HALEY WARD

23 April 2025

**RE: Response to TAC Review Comments at 361 Hanover Street, Proposed Site Development and New Structures**

**SITE PERMIT PLANS**  
**PROPOSED DEVELOPMENT**  
**361 HANOVER STREET**  
**PORTSMOUTH, N.H.**

**EASEMENT PLAN**  
**TAX MAP 138 - LOT 63**

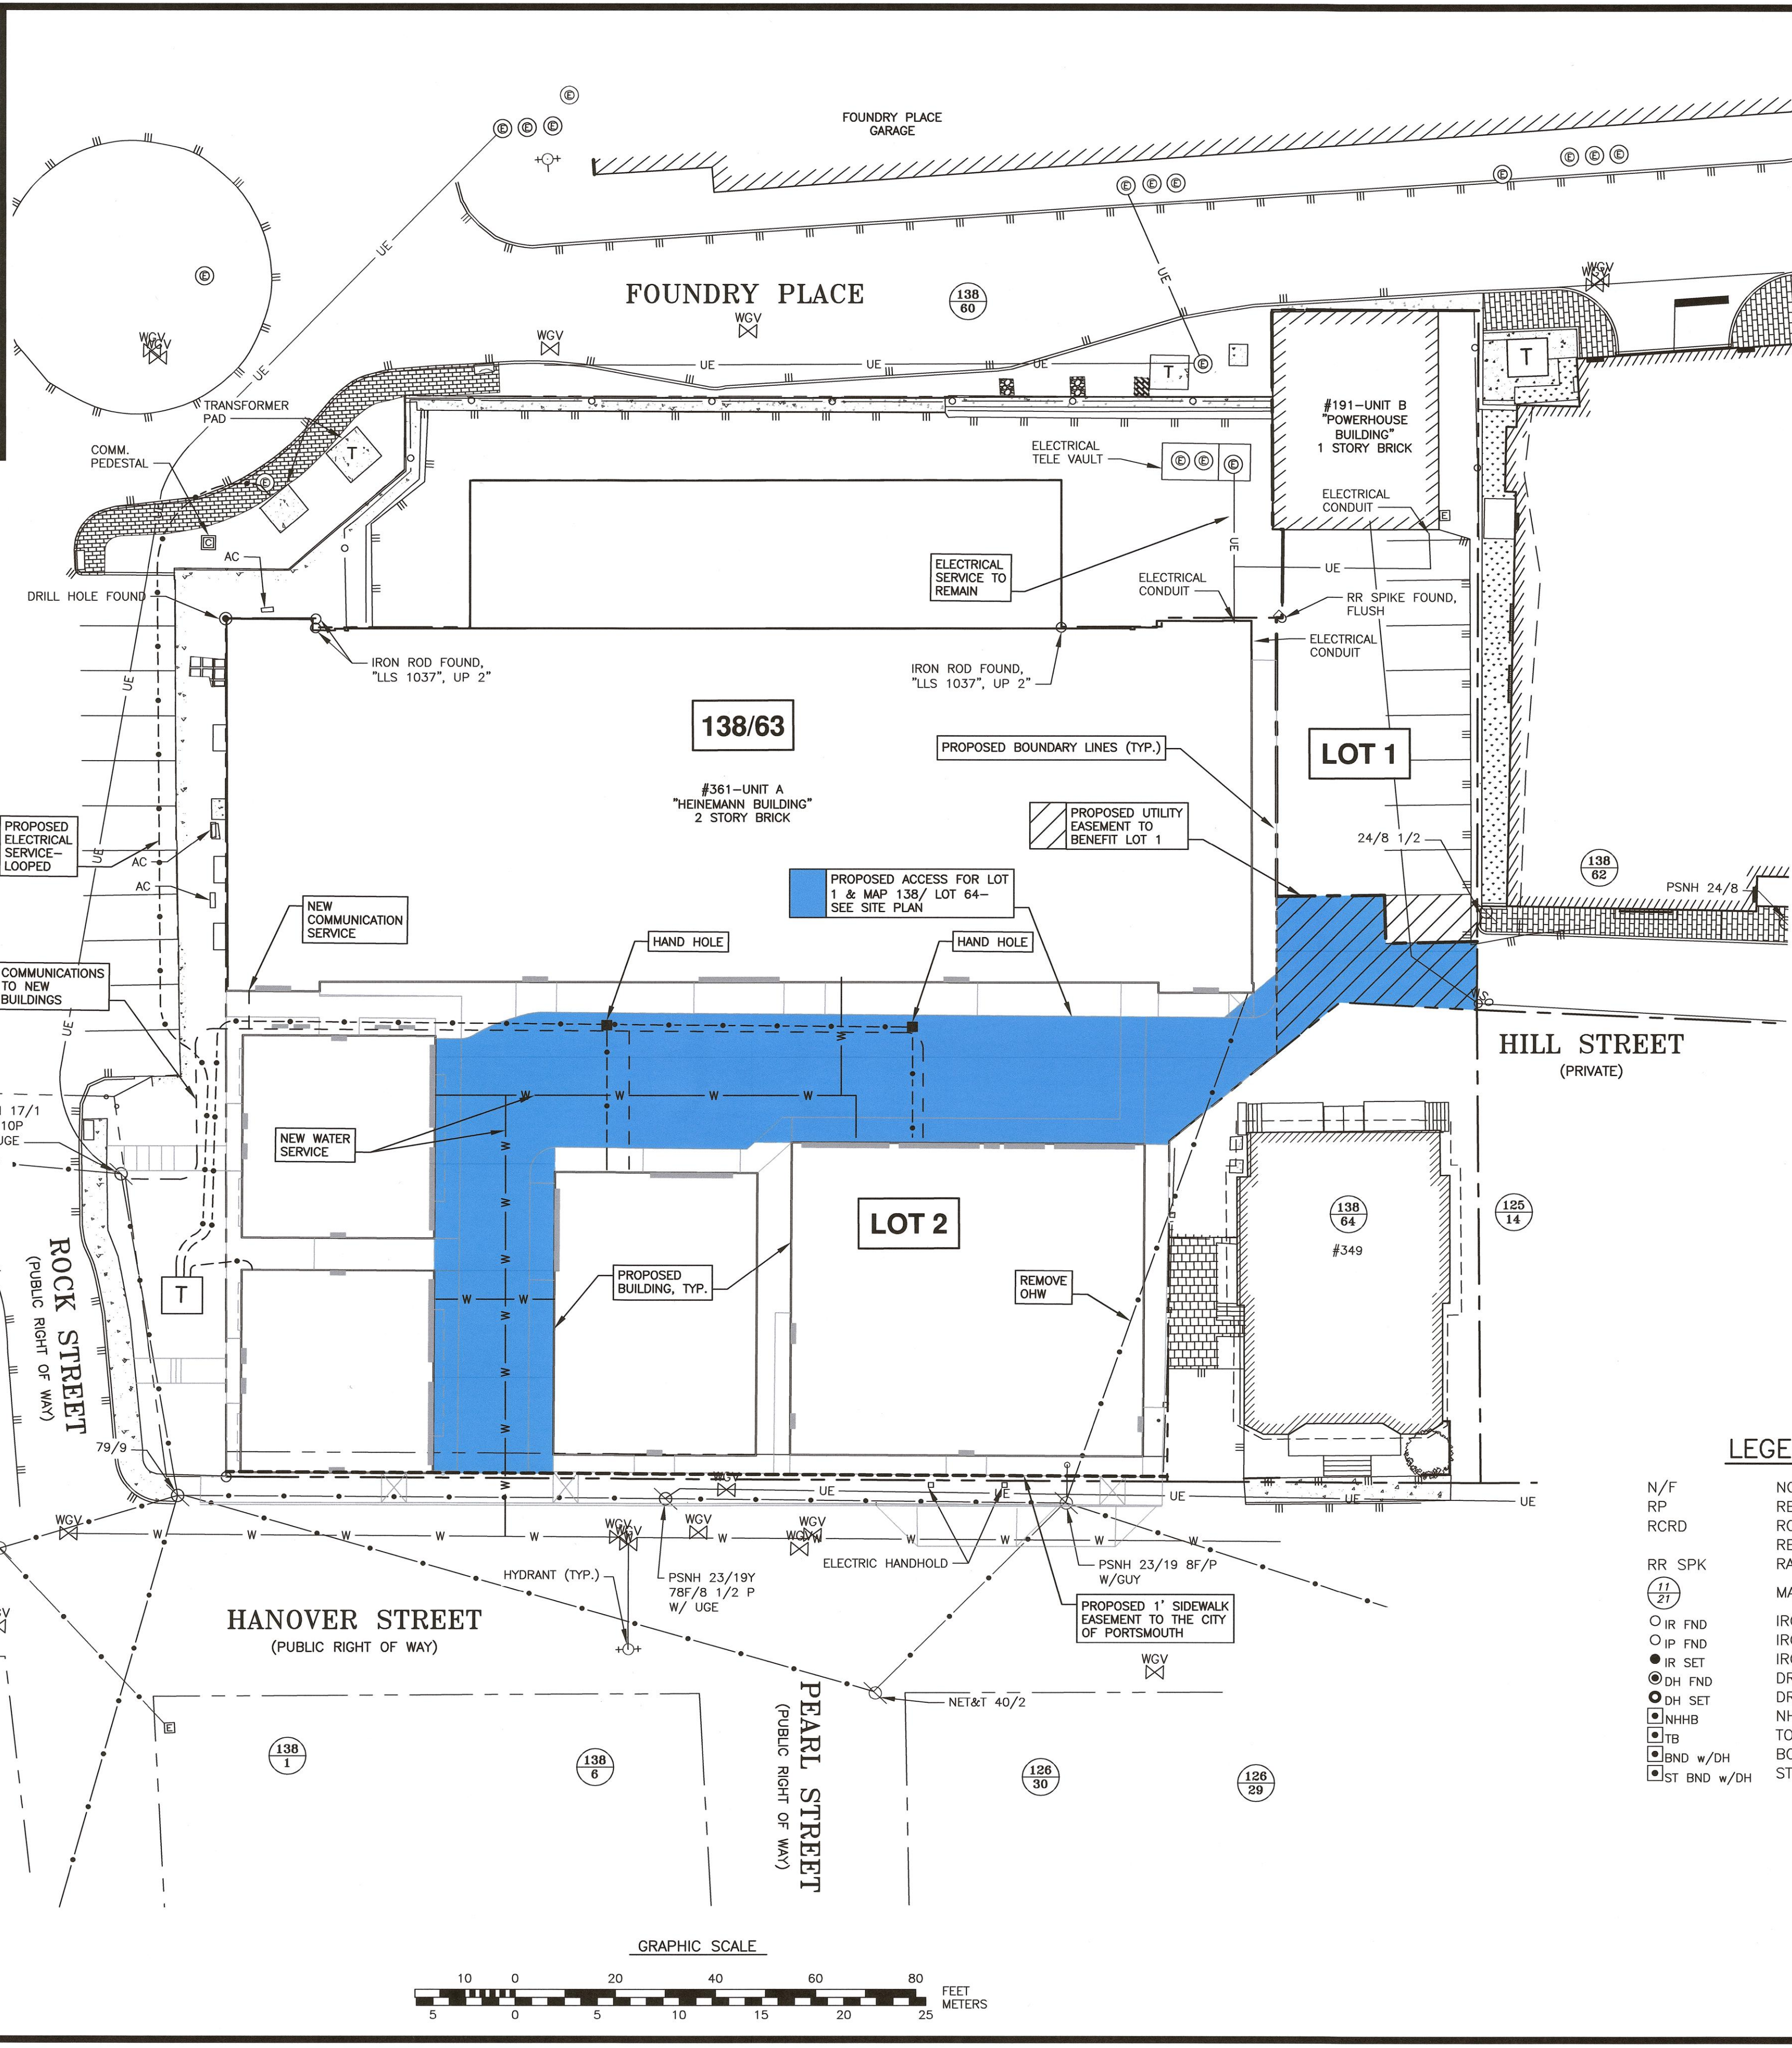
1. Please provide a subdivision checklist and relevant waivers. **This has been added to the submission.**
2. Please provide more details on the proposed access easement shown on the subdivision plan. **The plan set has been updated to include an Easement Plan showing additional detail.**

28. Flushing hydrant may be necessary if the private water main is not looped. **The water main does not have a terminal deal end.**
29. Leak detection and metering easement necessary here. **See Note 4 on the Easement Plan.**

DEMOLITION  
PLAN

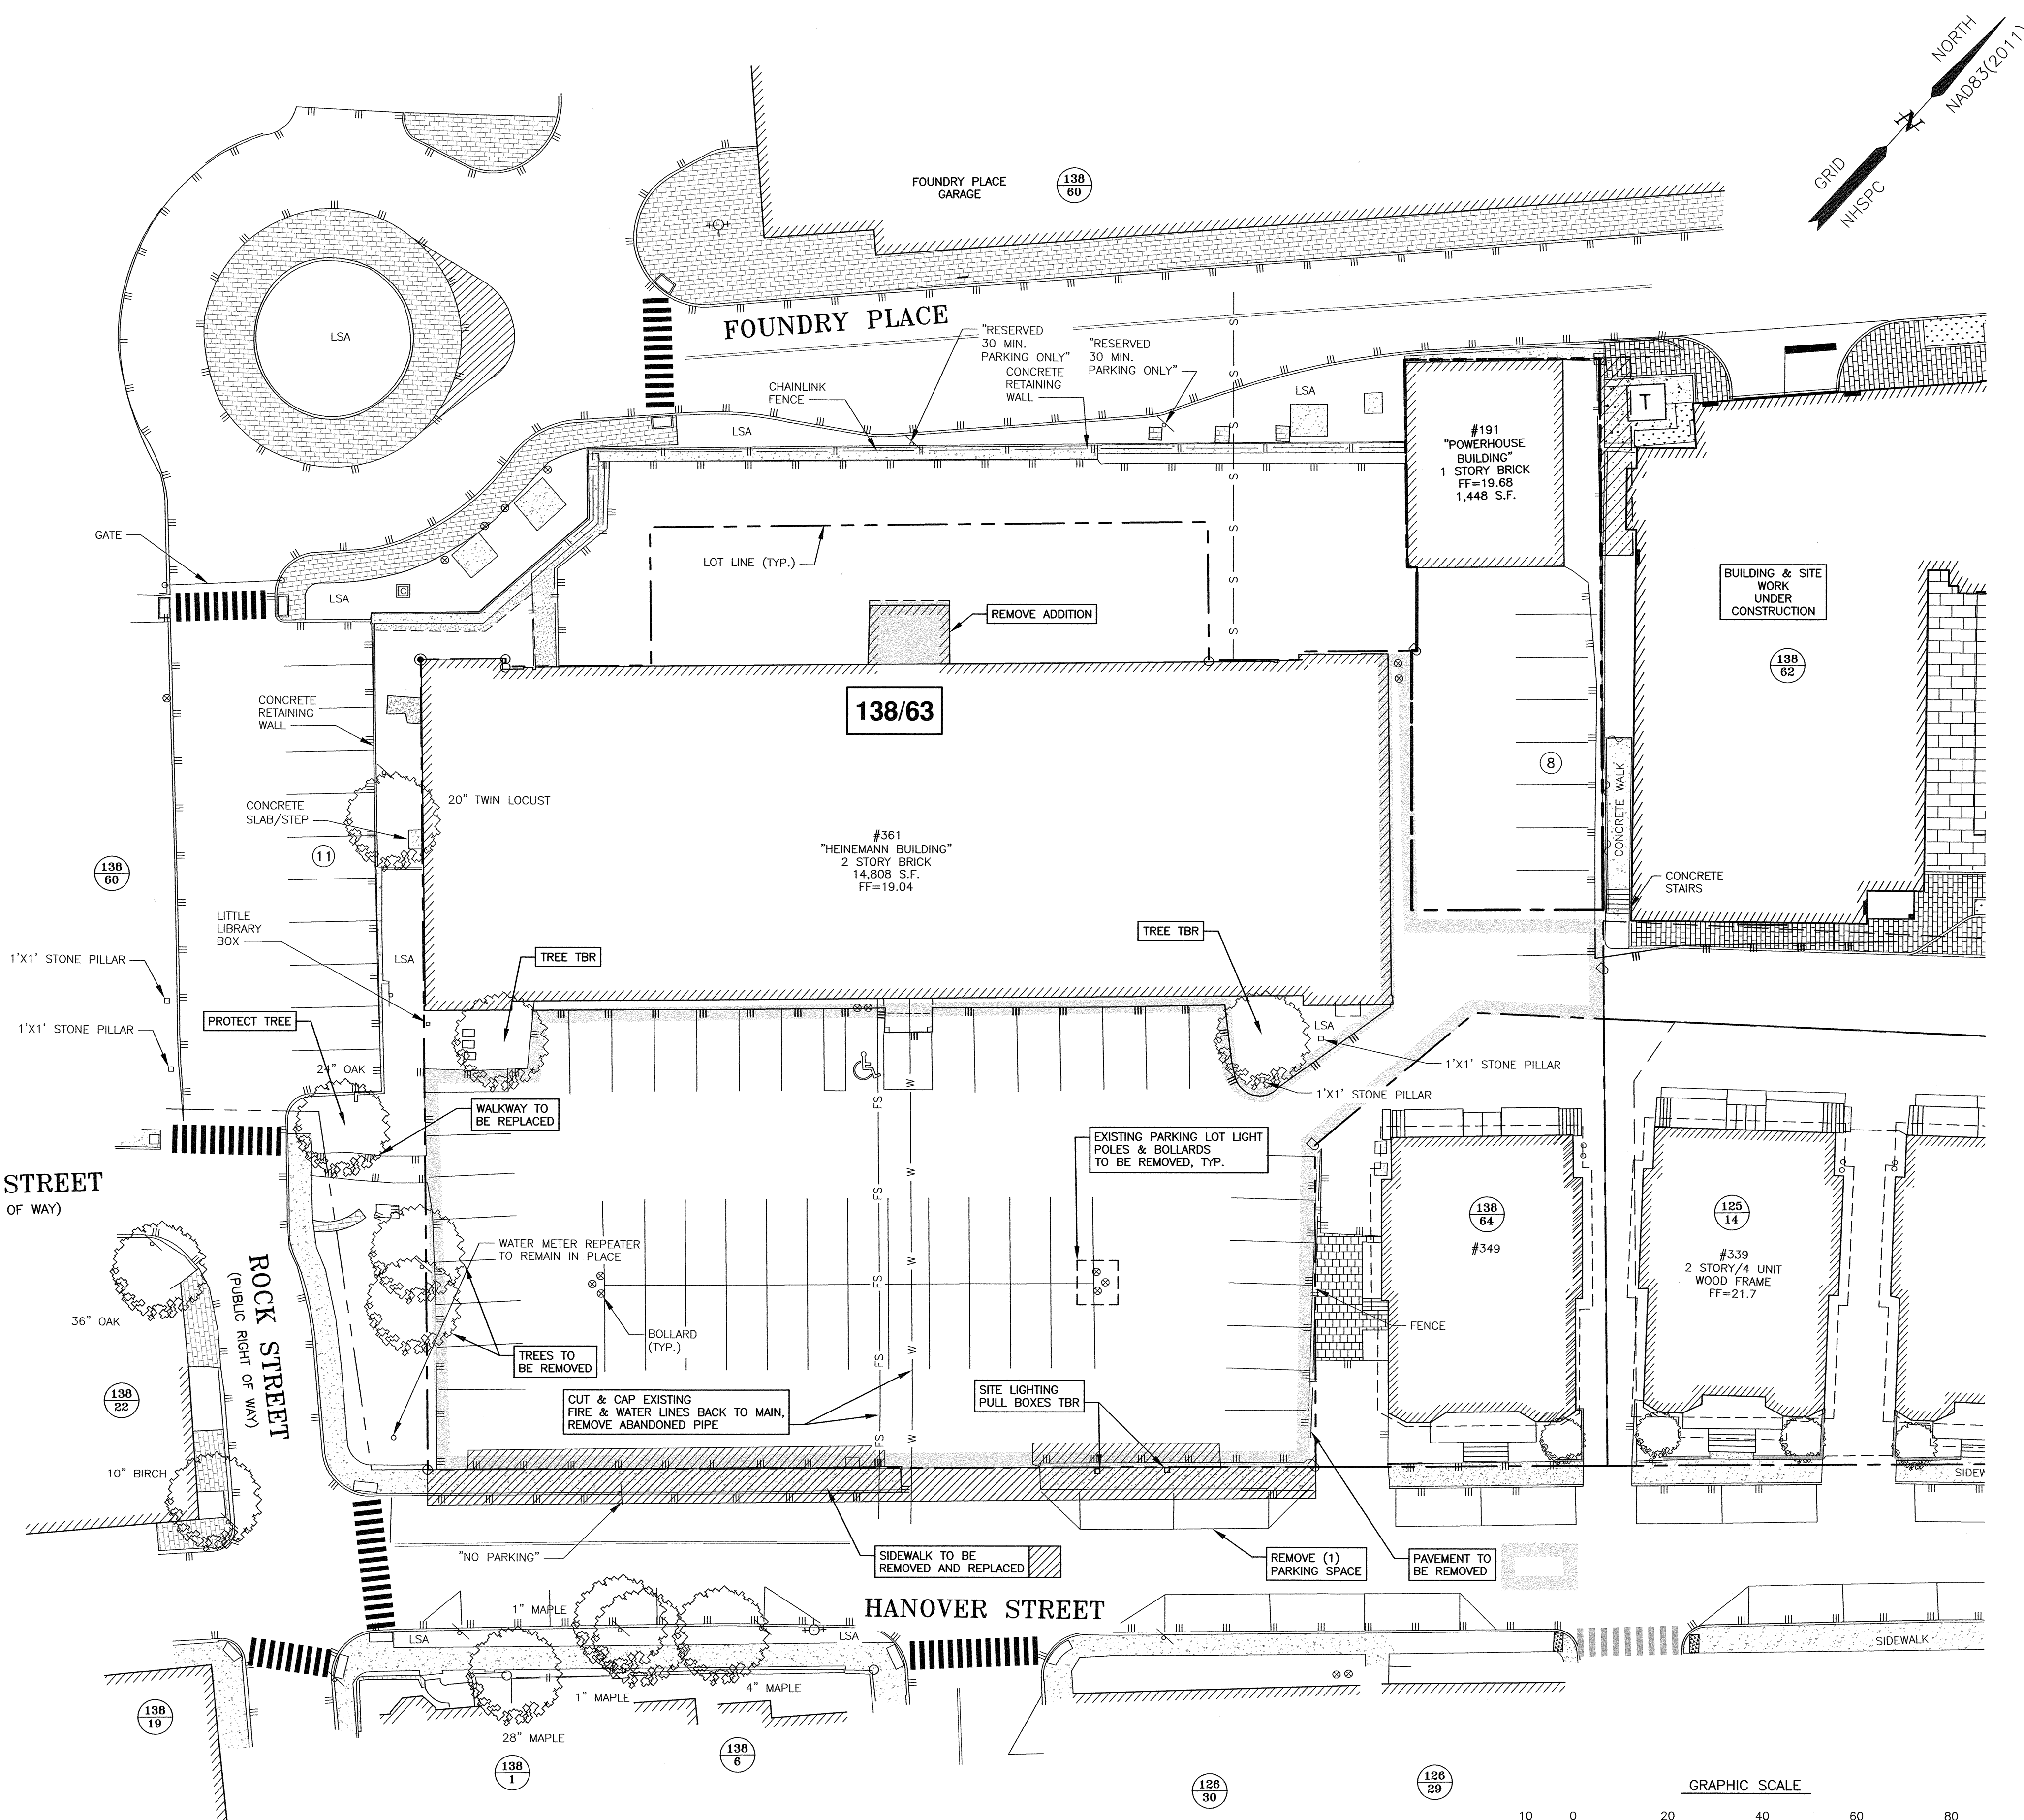
22. The demo plan shows existing sewer lateral to be cut and capped. Utility plan shows it to remain. Please update demo plan. **The Demolition Plan C2 has been updated.**

37. Please propose adopt-a-spot plantings for the area between units B 1 and B 2 and Rock St. **See Note 7 on Sheet C3.**
38. Cutting and capping of existing services is to be done at the main. **The Demolition Plan C2 has been updated with this note.**
